1101 H STREET NE / PUBLIC SPACE PERMIT #380565

FEBRUARY 24, 2022

The following Architectural drawings dated 02.03.22 and submitted to DCRA under building permit #B2109279 are provided to address the open comments for public space permit #380565. Additional dimensions and notes have been added for clarity per the comments below, but no changes to the drainage, projections, overhangs, etc. have been made to the building permit drawings.

SITE PLAN

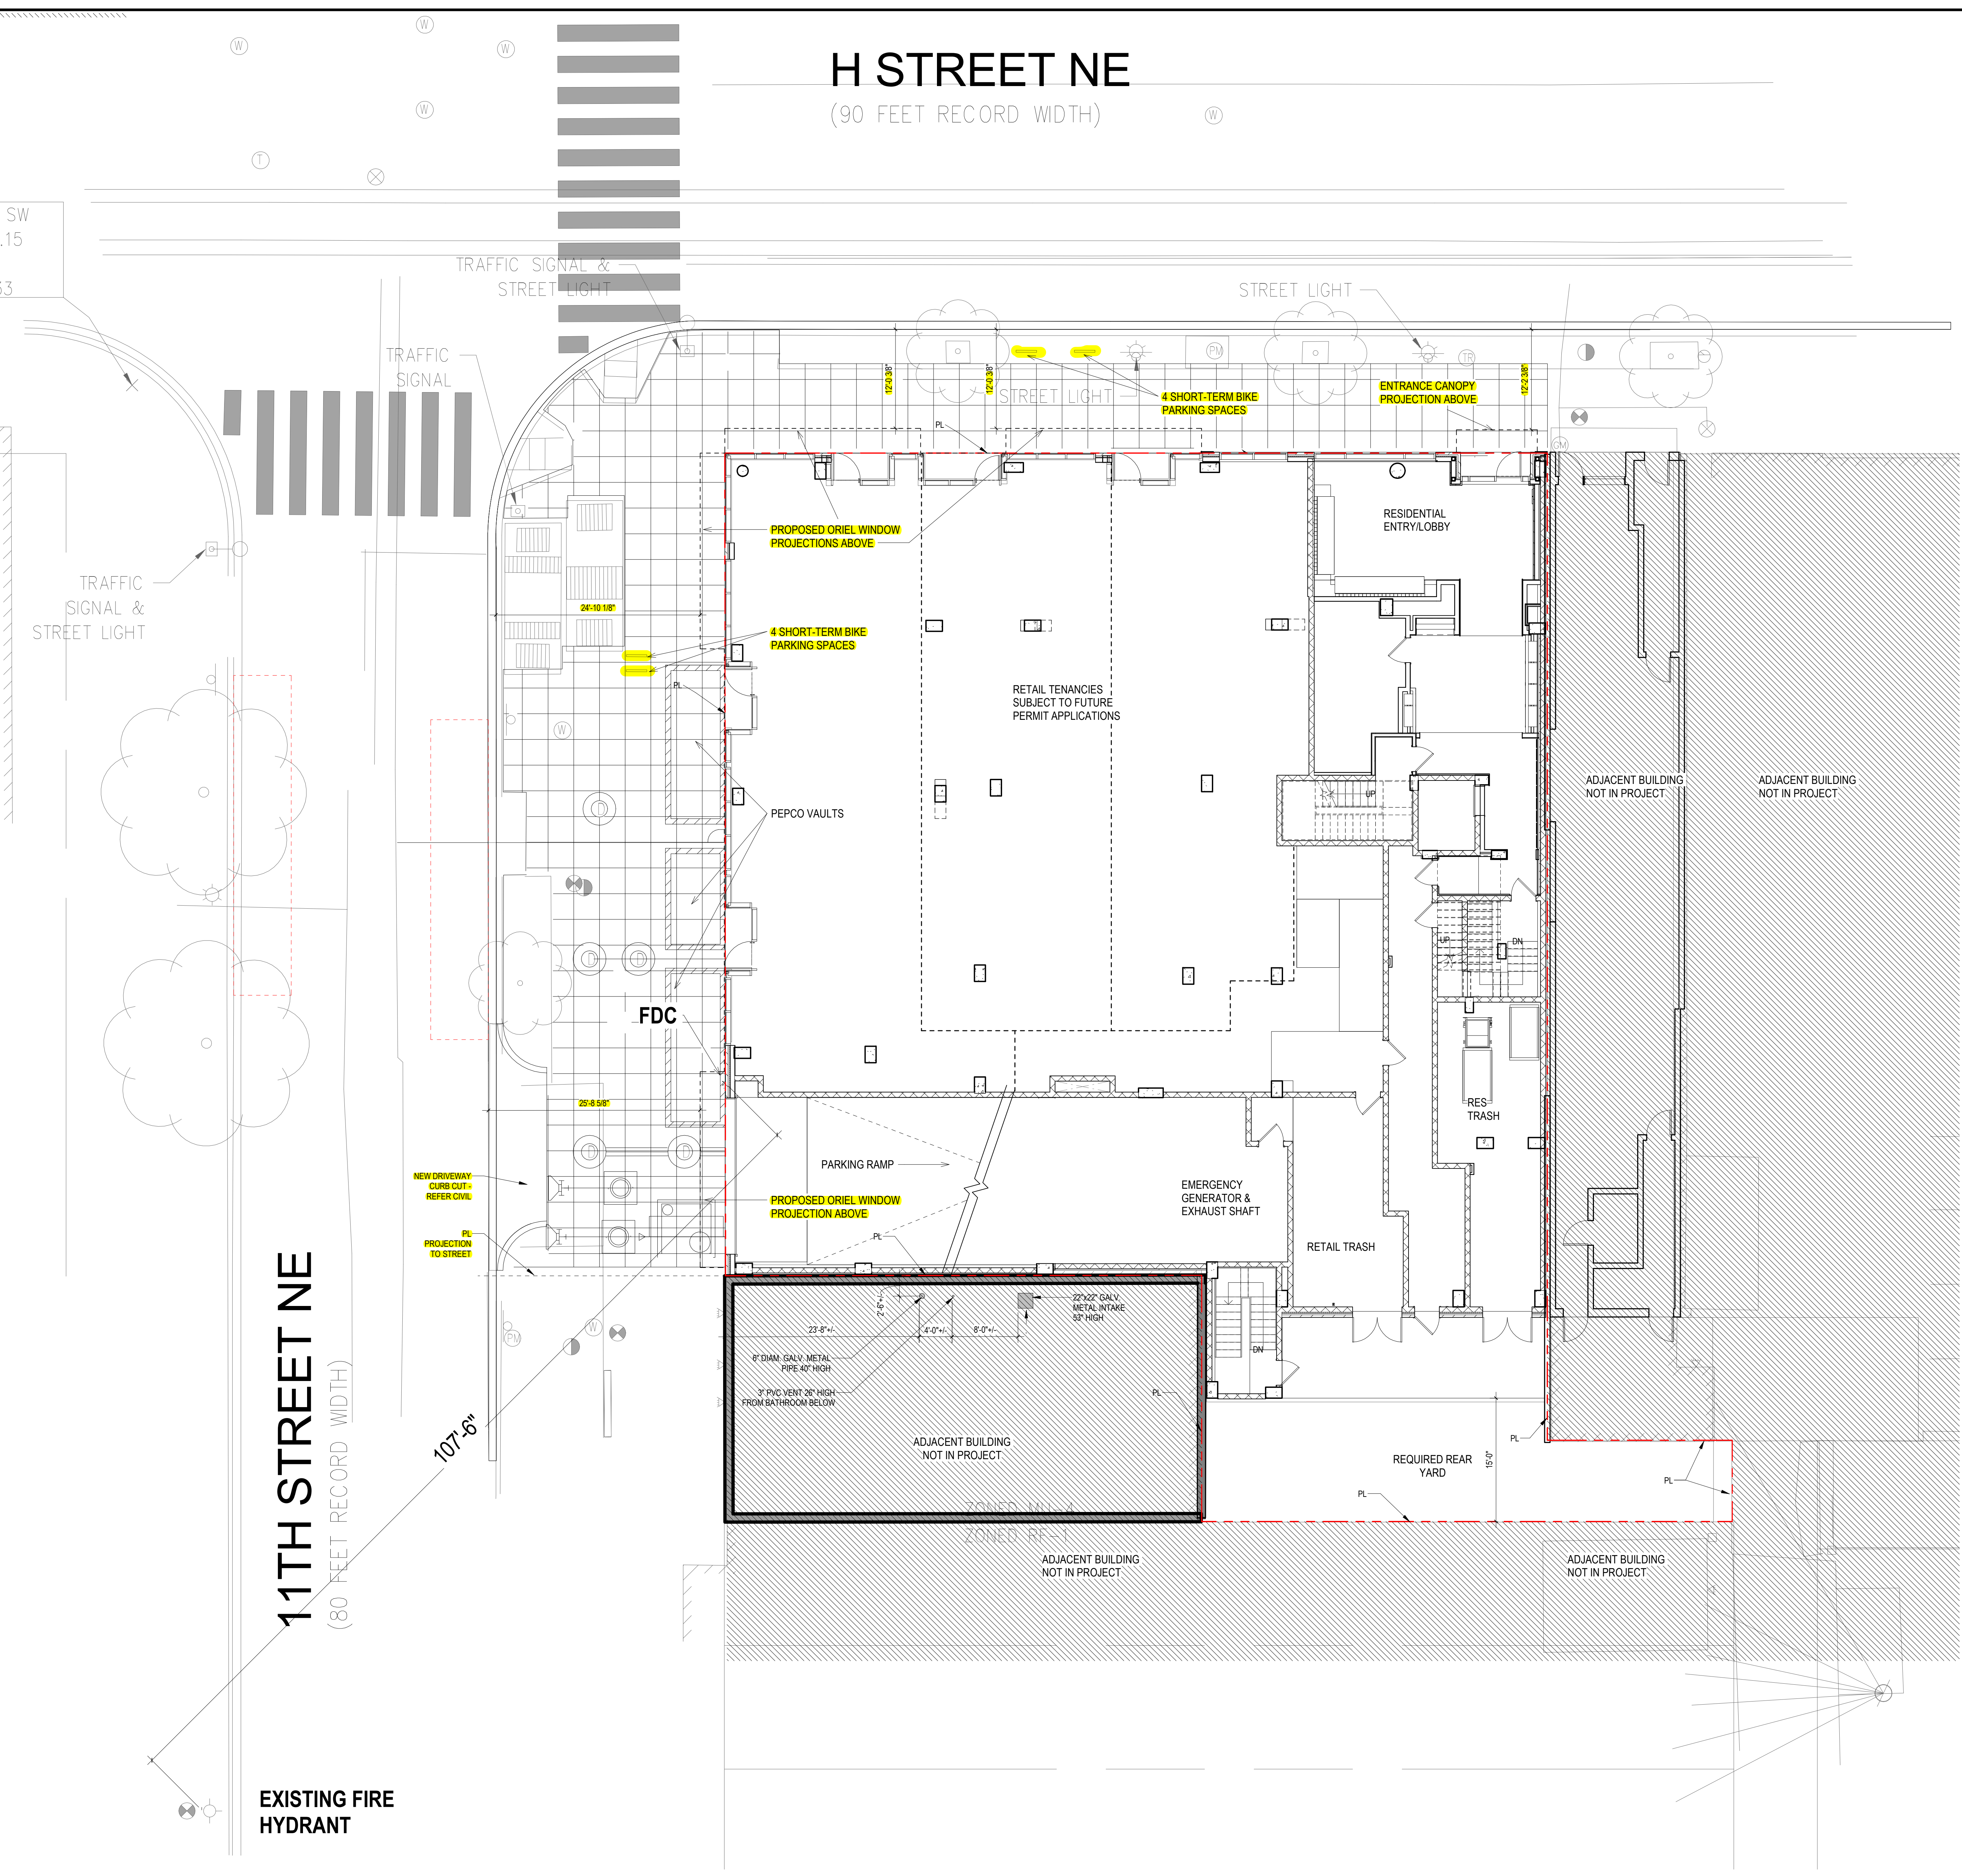
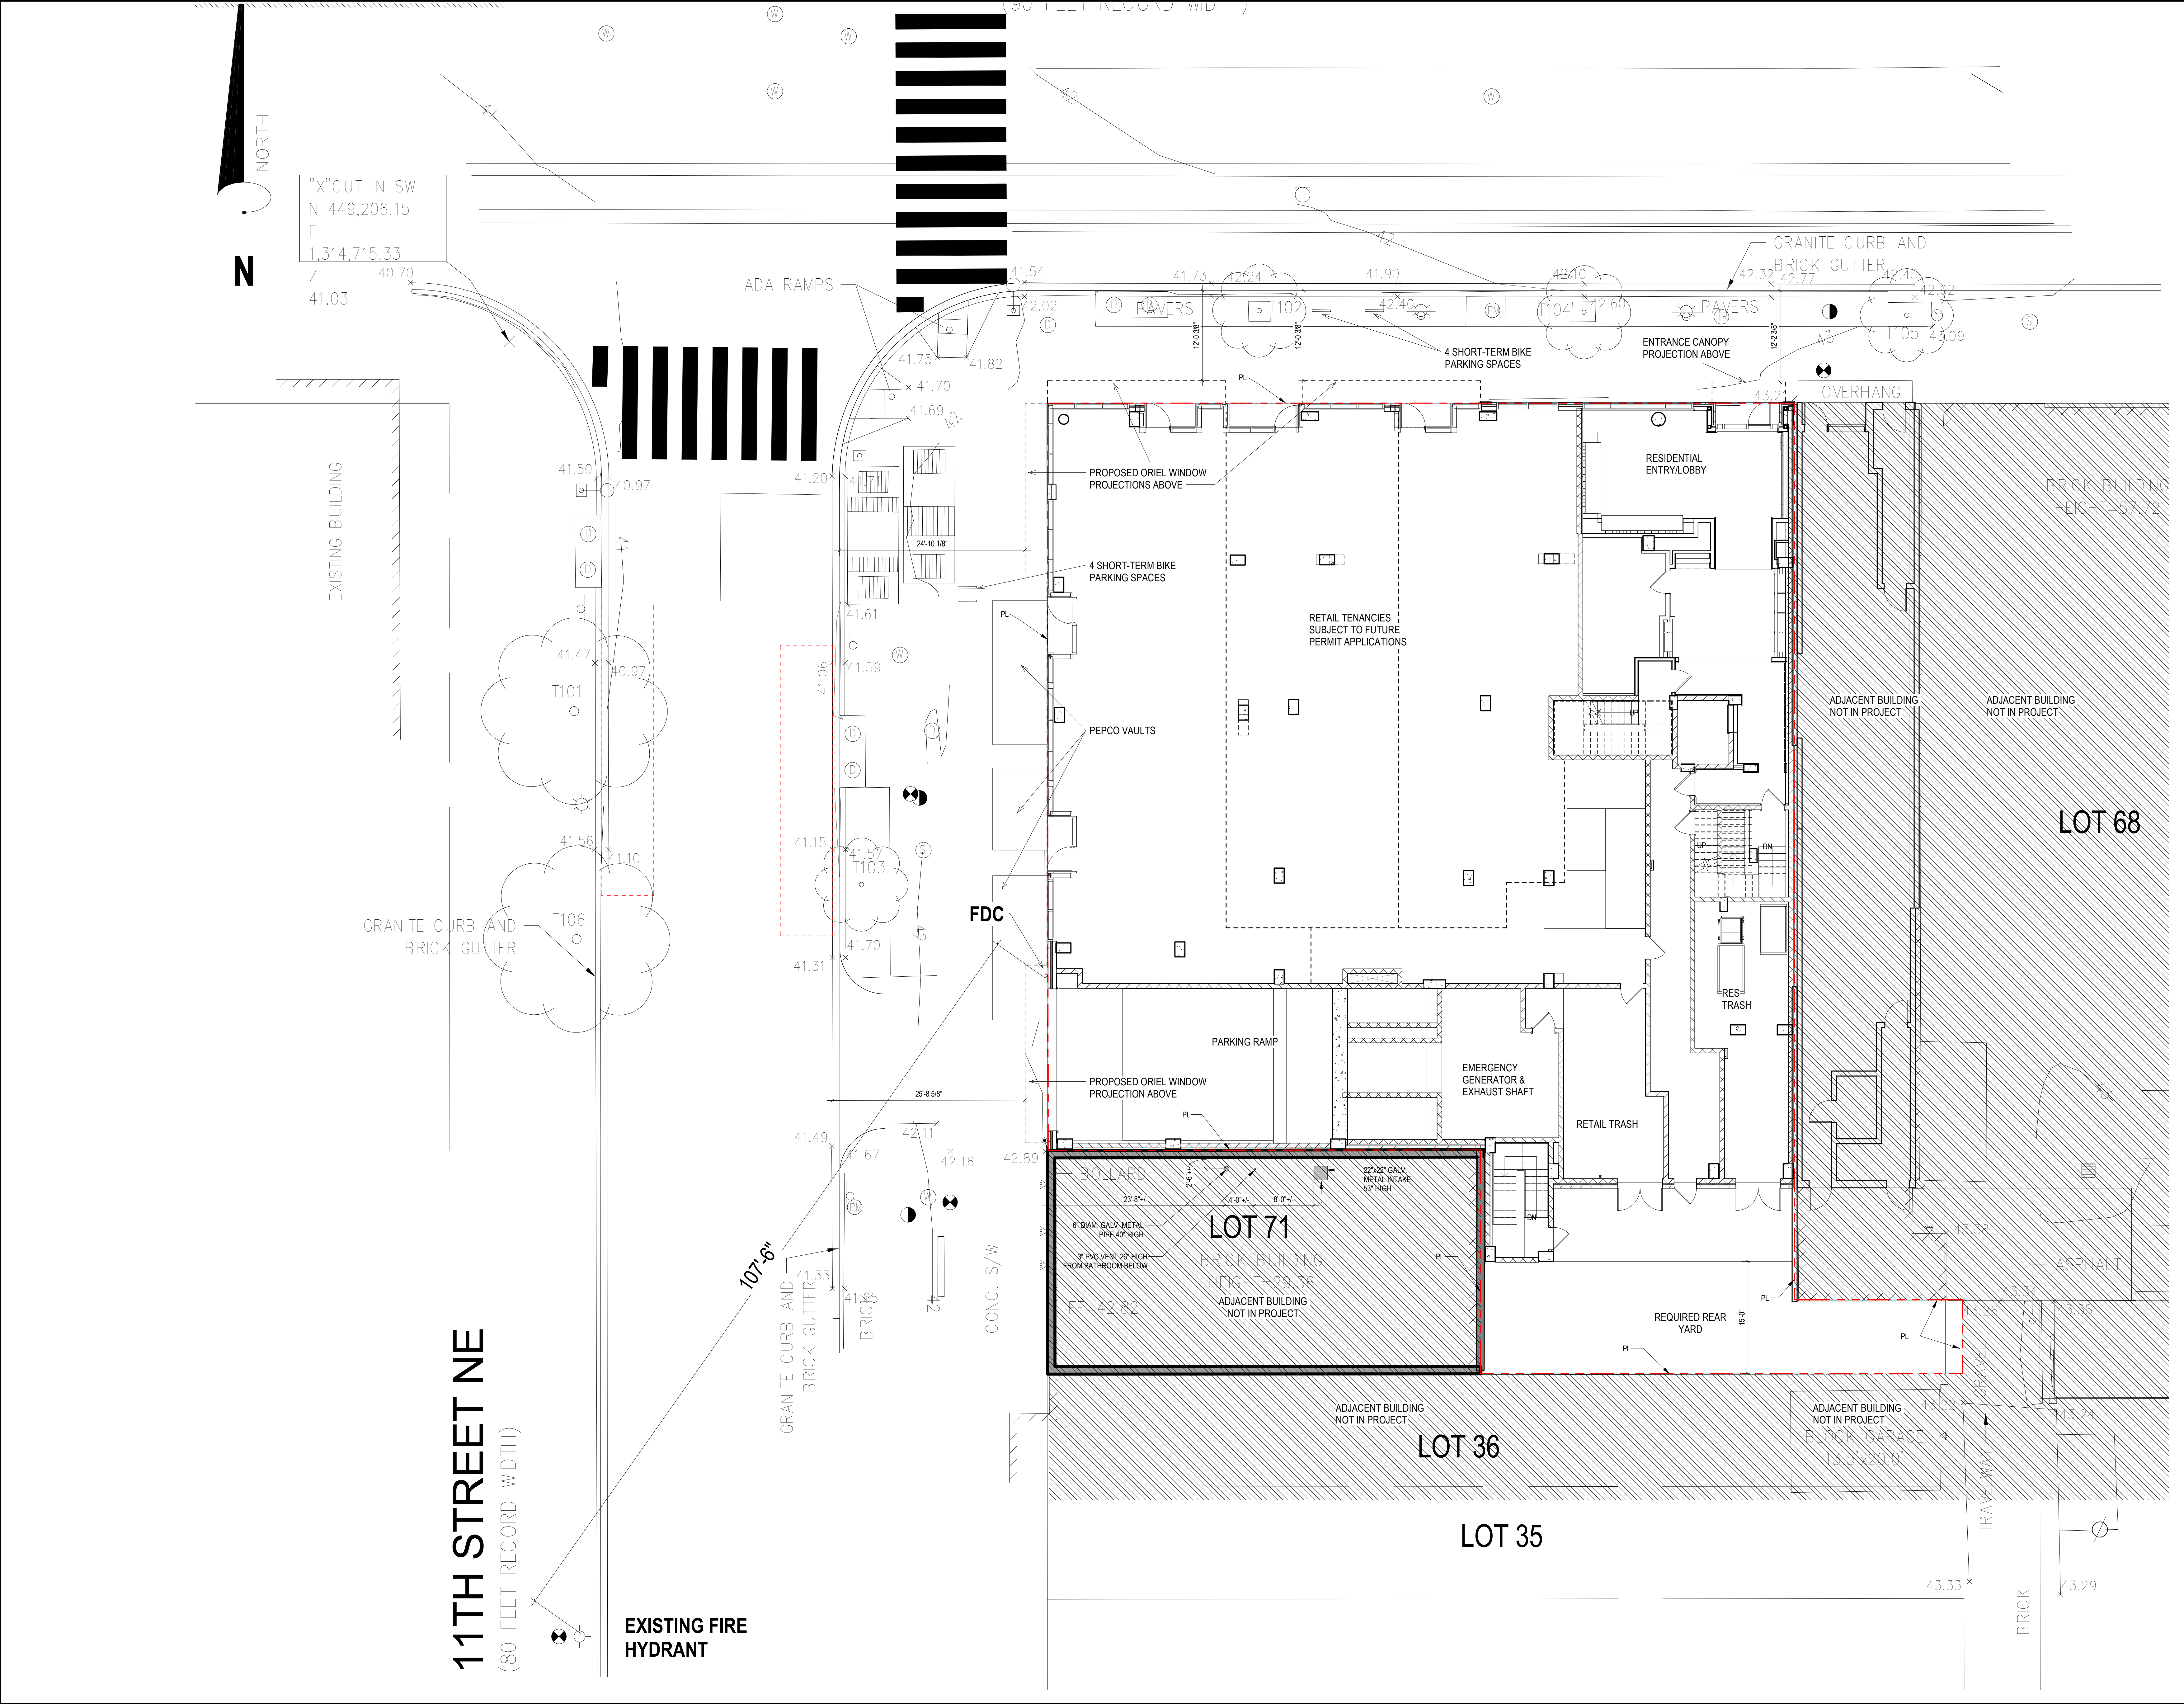
Reviewer	Description	Sheet References
IPMA/ Stormwater	Provide drainage information, including grading, drainage areas, inlets, and downspout locations to demonstrate that no impervious areas drain to the public space.	<p>A102 – 2nd – 6th Floor Plan shows dimensions for the projecting bays. 2ND Floor indicates terrace drainage is internal to property and no impervious areas spill to public way.</p> <p>A104 – Penthouse & Penthouse Roof Plan indicates roof drainage is internal to property and no impervious areas spill to public way. Downspouts from Penthouse roof to penthouse interior drains are indicated.</p> <p>A501 – Exterior Sections indicate impervious canopy drainage is directed to interior of building rather than public way.</p>
OP – Urban Design	<p>Provide additional floor plans that show parking locations and access route, so that OP can fully review the location and design of the proposed curb cut. Curb returns for the driveway must remain within the lot line extended to the curb. Curb returns may not cross over into the public space that is in front of an adjacent property.</p> <p>Please submit elevations, sections, and other relevant details regarding the proposed building projections and overhangs. Per the DCMR Title 12A Section 3202.7.1.1, building projections must maintain a minimum of 12' offset from streets with a right-of-way width of 90', such as H Street NE. Please reduce projecting distance of the proposed bay windows on H Street to maintain a minimum 12' from the curb line. OP</p>	<p>003 – Site Plan indicates dimensions from curb to projecting bay at H Street NE provided as 12'-0 3/8" minimum, and 24'-10 1/8" at 11th Street NE. note: Curb cut at driveway extends past the lot line when extended to the curb due to existing site constraints and is under review with DDOT.</p> <p>A101 – 1st Floor and Cellar Plan shows parking locations and access route.</p> <p>A102 – 2nd – 6th Floor Plan shows dimensions for the projecting bays. 2ND Floor indicates terrace drainage is</p>

Response: **Refer to sheet 003 which indicates dimensions from curb to projecting bay at H Street NE provided as 12'-0 3/8" minimum, and 24'-10 1/8" at 11th Street NE. Replacement driveway curb cut is with lot line when projected to the curb. Sheet 010 indicates the extent and locations of projecting bays. Sheet A101 shows**

Sheet 003 indicates (4) short term bike spaces on H Street and (4) short term bike spaces on 11th Street. Street. Dimensions from curb to projecting bay at H Street NE provided as 12'-0 3/8" minimum, and 24'-10 1/8" at 11th Street NE. Sheet 010 indicates extent and locations of projecting bays.
